SUBJECT Responses to Questions JOB # I-348

Ref: Questions on Final Report

RESPONSES TO QUESTIONS
SIX-METER ANTENNA STUDY
FOR
SMITHSONIAN ASTROPHYSICAL
OBSERVATORY

FIGURE 2-2

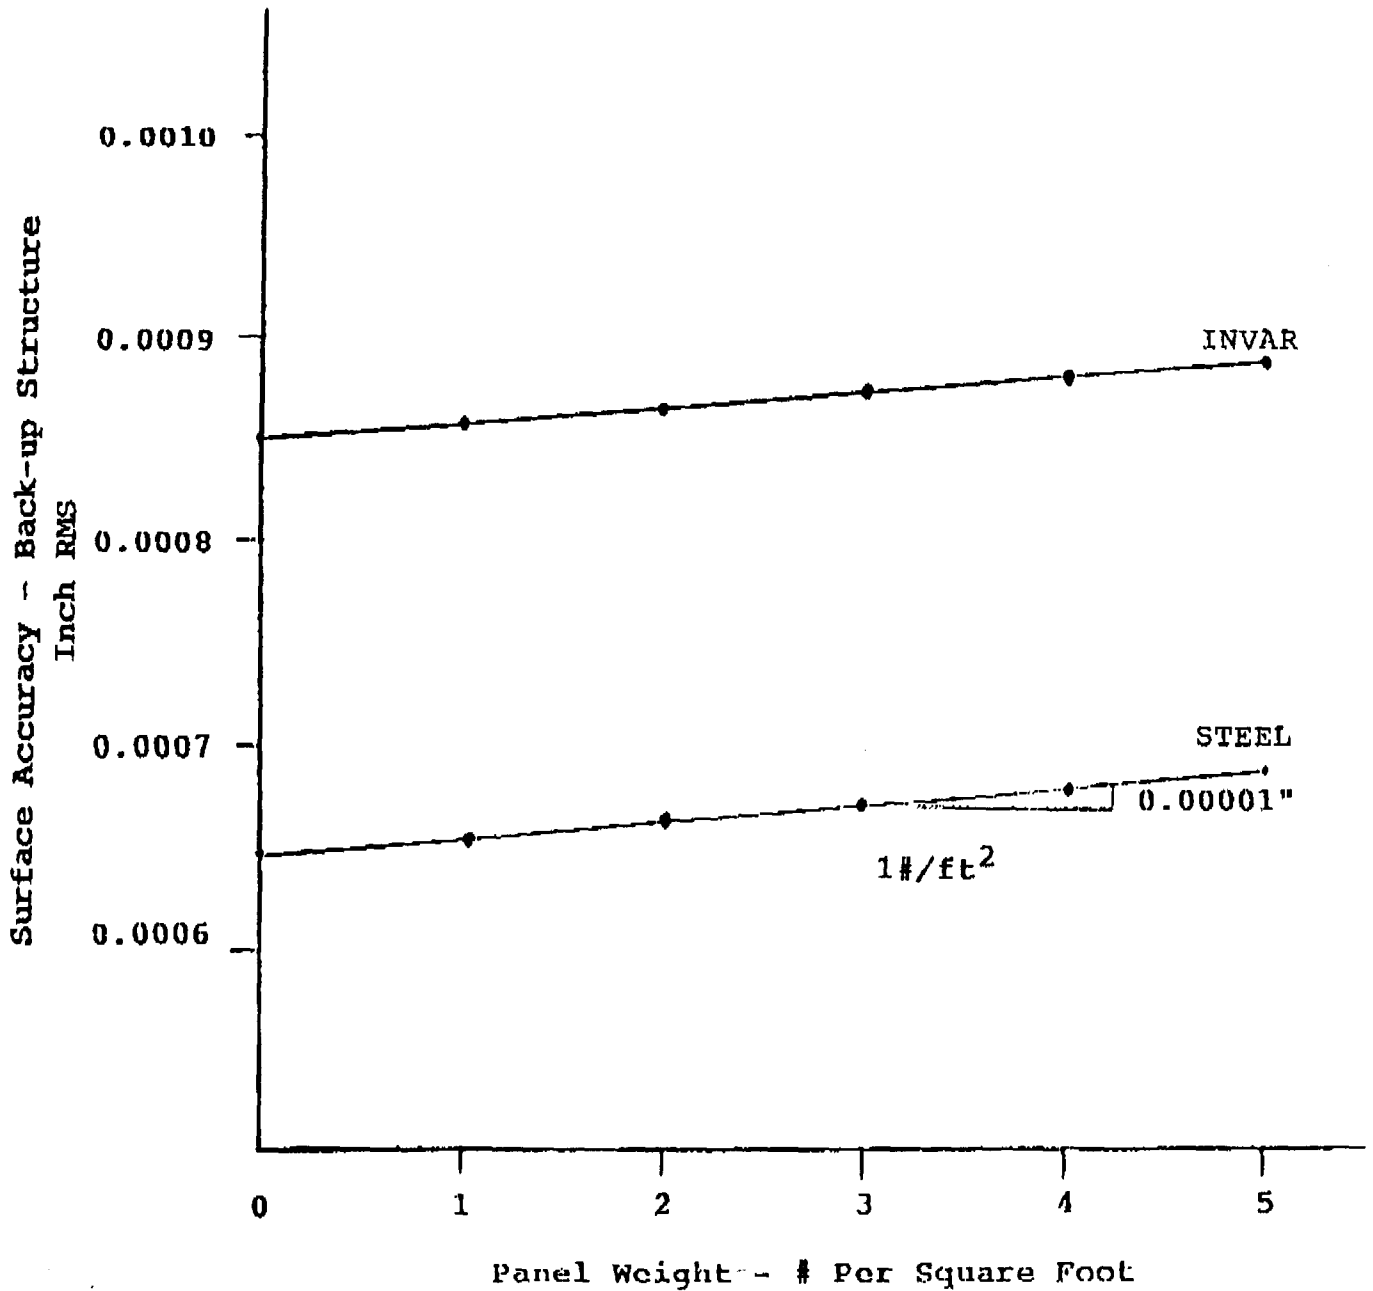
In Figure 2-2 is the top curve invar and the bottom curve steel? What kind of attachment scheme is used between the elevation wheel and the reflector? Could it be modified to reduce the CTE mismatch problems for the aluminum and carbon fiber backstructures which are illustrated in Table 2-3? Also, what effect will the CTE mismatch problem between aluminum panels and a steel backup have on the performance?

A corrected version of Figure 2-2 is attached showing the top curve as invar and the bottom curve as steel.
